Western Sub Regional RTEP: AEP Supplemental Projects

February 13, 2026

Changes to the Existing Supplemental Projects

s3440.3: Posted in 2024 Local Plan. Need Number: AEP-2022-OH071. Need Meeting 10/14/2022. Solution Meetings 5/9/2023, 12/5/2023.

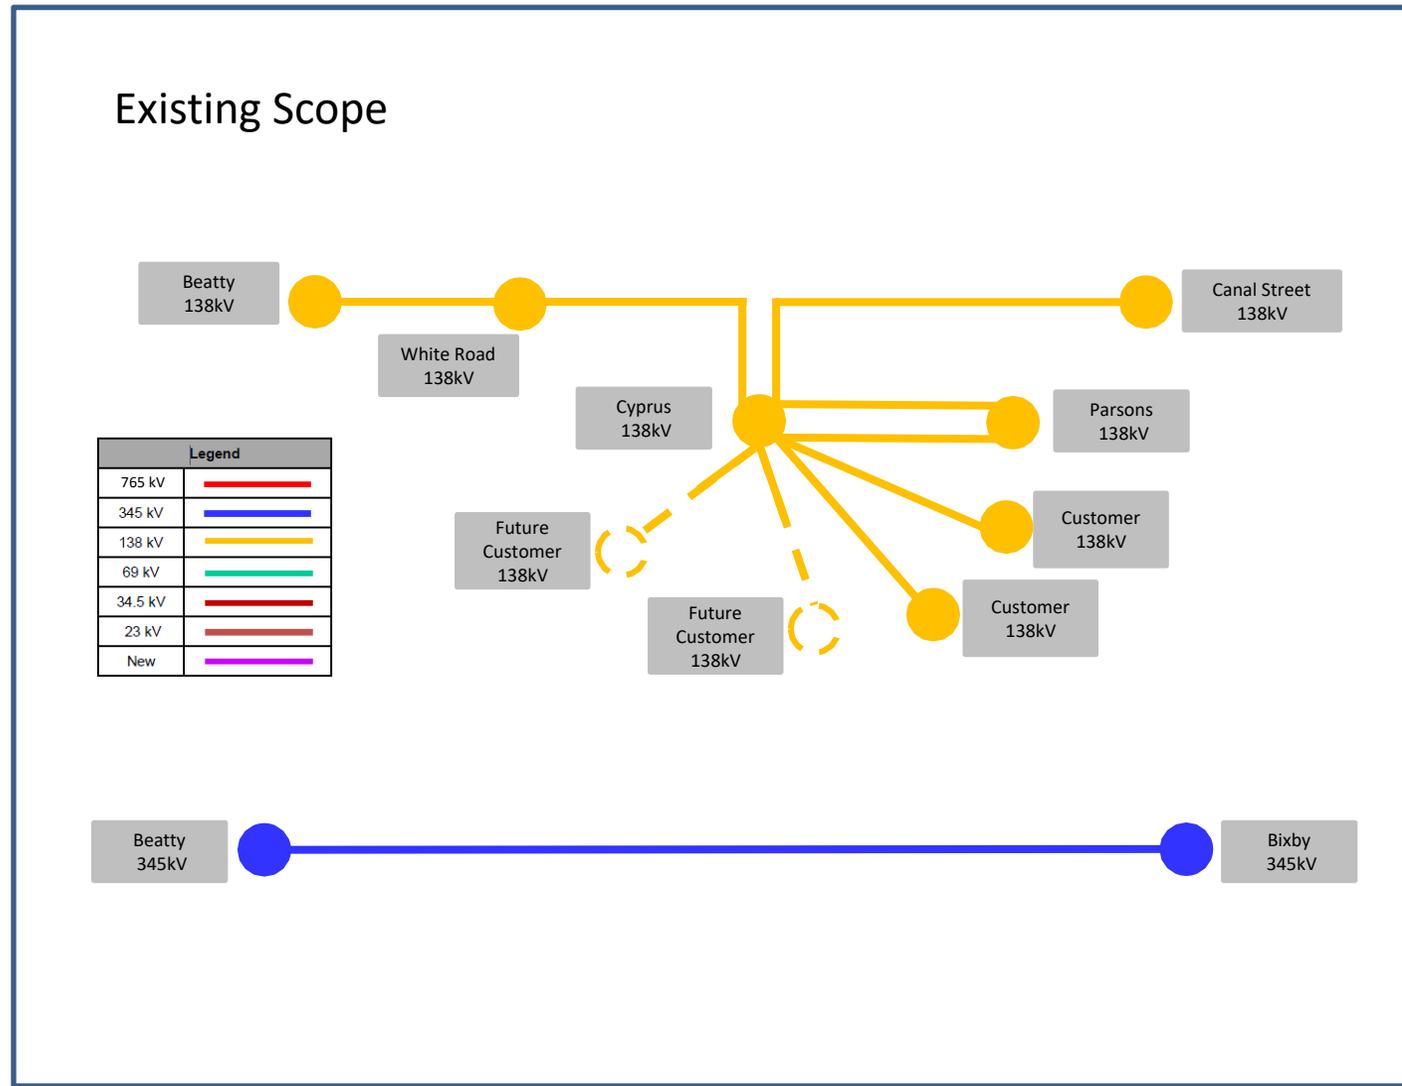
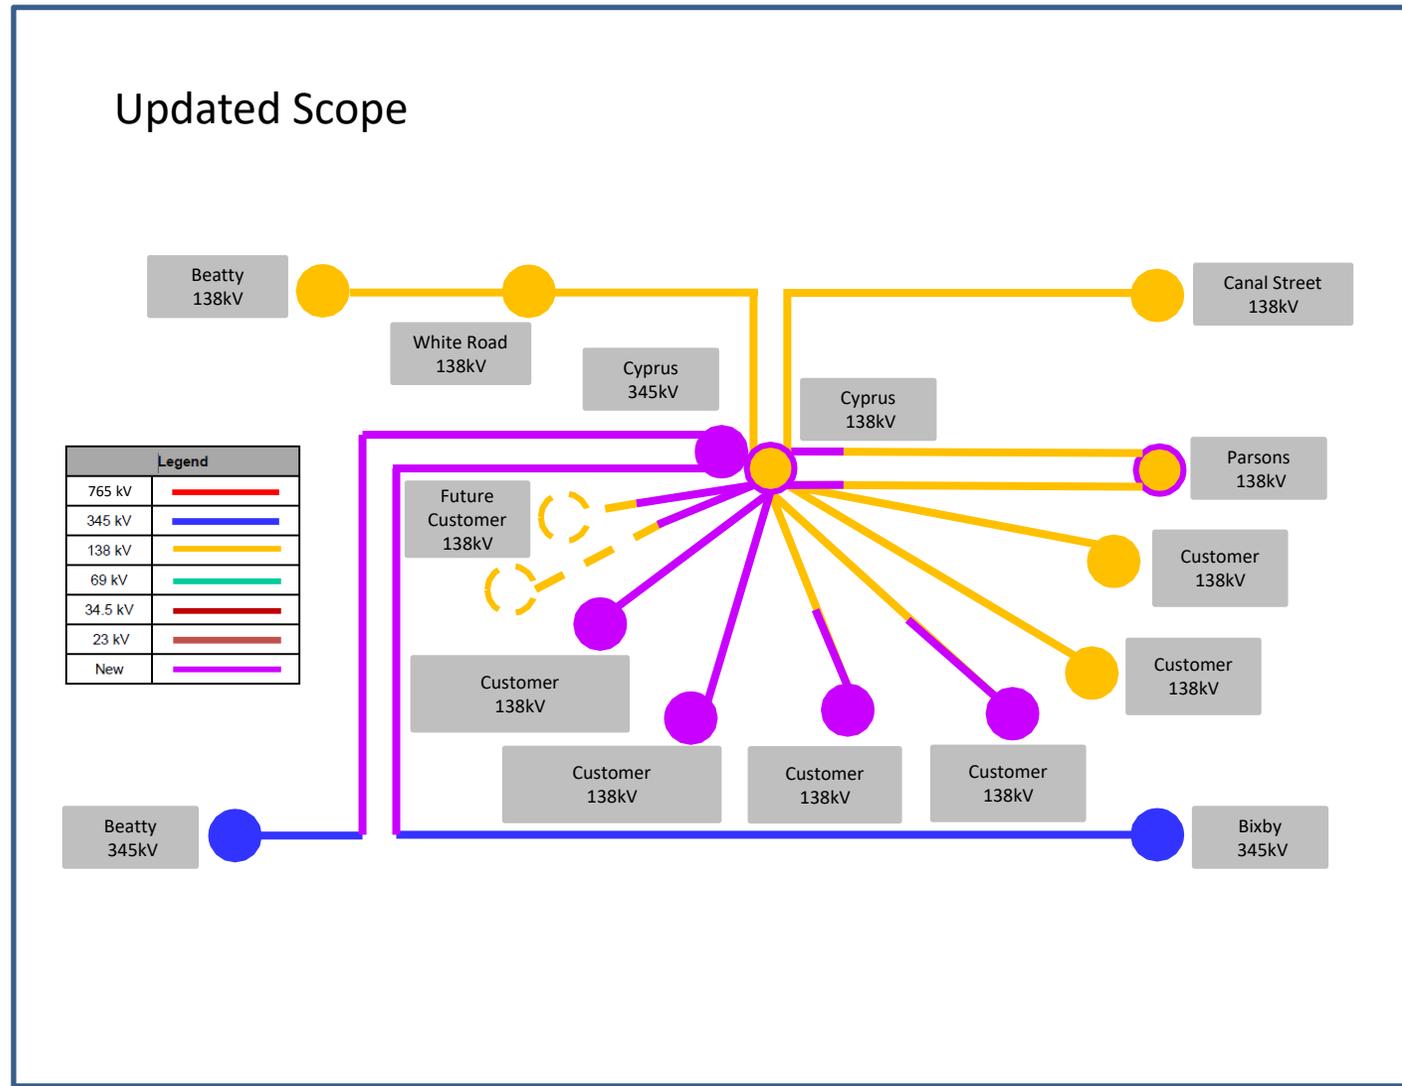
Reason For Change: The sag study conducted on the Beatty-Canal 138kV line identified the majority of the structures needing to be replaced in order to meet needed clearances to be able to operate at MOT. With those findings along with loadings forecasted to increase over the years, the scope has been updated to a rebuild of the Beatty-Canal 138kV line.

- Beatty – Canal 138 kV line Sag Re-rate-Rebuild:** The Beatty – Canal 138 kV line flagged as overloading under N-1-1 scenarios after the addition of the new load in Cyprus. The line will be flown to address sag issues that are limiting its current rating. It is anticipated that several structures will need to be replaced in order to raise the rating of the line. The sag study identified most of the structures along the line needing replaced. Thus, the line will be rebuilt using 795 ACSS Drake and 1033.5 ACSS Curlew to address the findings of the sag study as well as loading conditions that have continued to increase annually. Cost: ~~\$5.5 M~~ **25.4M(s3440.3)**

Total Estimated Transmission Cost: ~~\$57.5M~~ \$77.4M
